Supplier Deviation Disposition Request

PROJECT: River Protection Project Waste Treatment Plant

FOR RPP-WTP USE			
RPP-WTP SDDR No. 24590-WTP-SDDR-HV-10-00001	Rev. NA	DATE RECEIVED 03-Feb-10	
FOR SUPPLIER USE			
SUPPLIER SDDR No. SDDR-80100-5		DATE SUBMITTED 2/3/10

Title of SDDR: Safe Change HEPA Filter Housing - LAW-MK-LVP-HEPA-00001A/B; -00002A/B; & -00003A

Figure 1: LVP Model with Support Frame

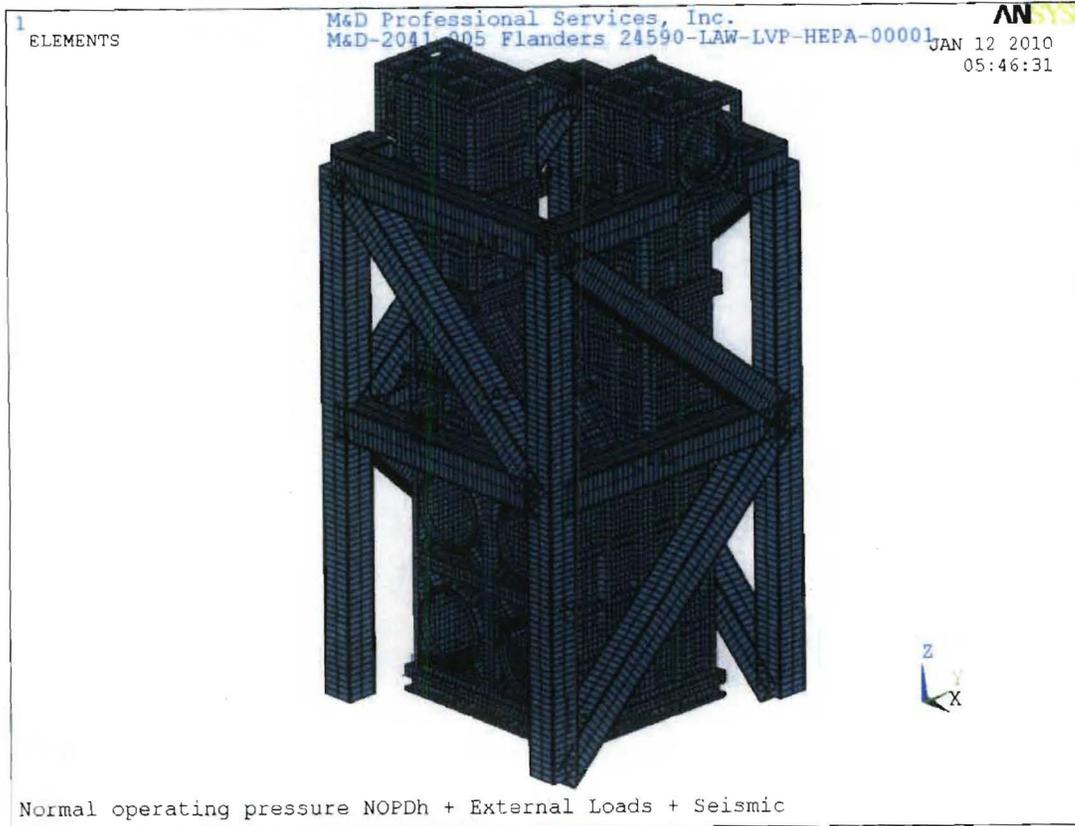
The LAW-LVP Data Sheet 24590-LAW-MKD-LVP-00013, Rev 2 (also in Flanders' submittal 24590-QL-POA-MKH0-00001-01-00039, Rev 00A) provided nozzle loadings (page 4 of DS) based on CCN 139983. However, based on Flanders' initial evaluation of the design requirements, these nozzle loadings are too high for this type of safe change (4-pack) HEPA filter housing design, and will require "massive" structural reinforcement and support (not acceptable option) as reflected in Attachment A (For Information Only).

This support frame was designed to handle the LVP's large nozzle loading.

Based on this SDDR, Flanders will apply a 350-lb mass (in lieu of 250-lb as initially proposed in this SDDR) in 3 orthogonal directions, and 10" moment arm to simulate potential applied moments at the nozzle in the structural analysis as well as during the seismic testing of a prototype unit.

This SDDR resolution will be reflected in Flanders' re-submittal of Data Sheet 24590-QL-POA-MKH0-00001-01-00039, specifically, deleting the tabulated interface design load requirements, and specify the 350-lb mass loading as described above.

Figure 2: LVP Stress Results with Support Frame (Von Mises)

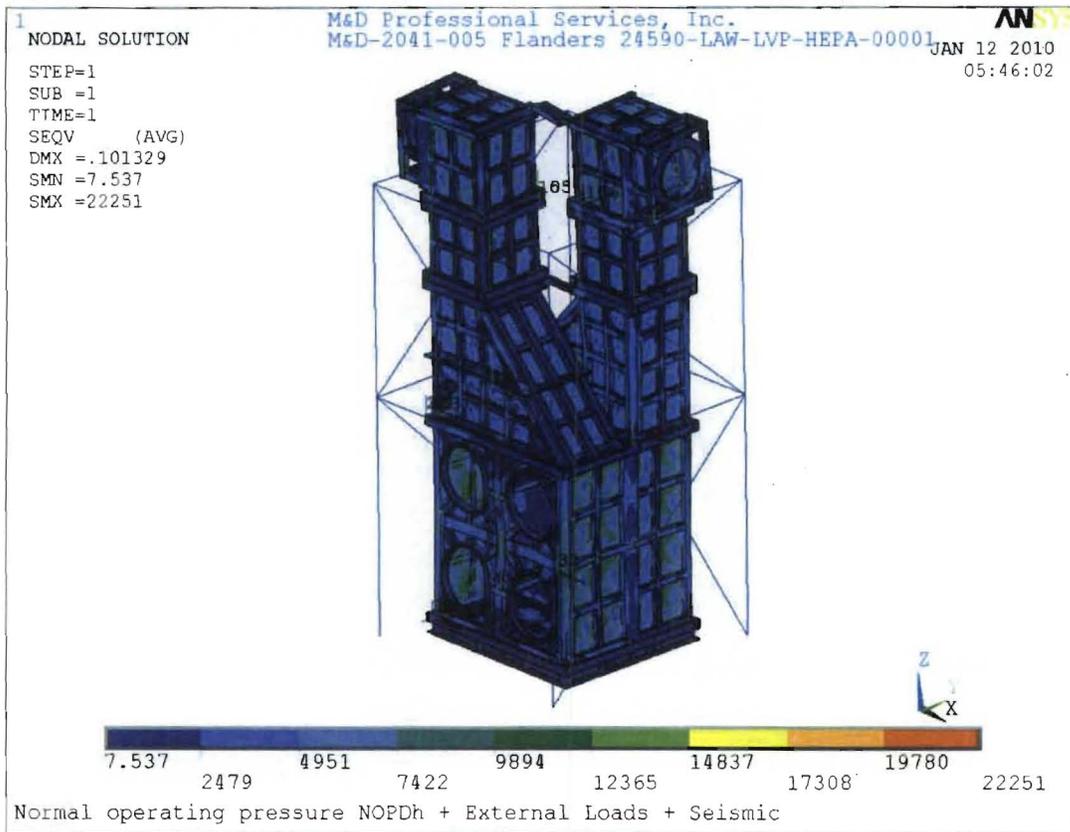
Normal Operating Pressure + DW + (Weight+Thermal+Seismic) External Nozzle Loads + Seismic:

Pressure= -195"wg

1g in Z-Direction

0.4g in X-Direction

0.4g in Y-Direction

Nozzle Loads used with all forces are in the (-) Direction and all Moments are in the (+) Direction.
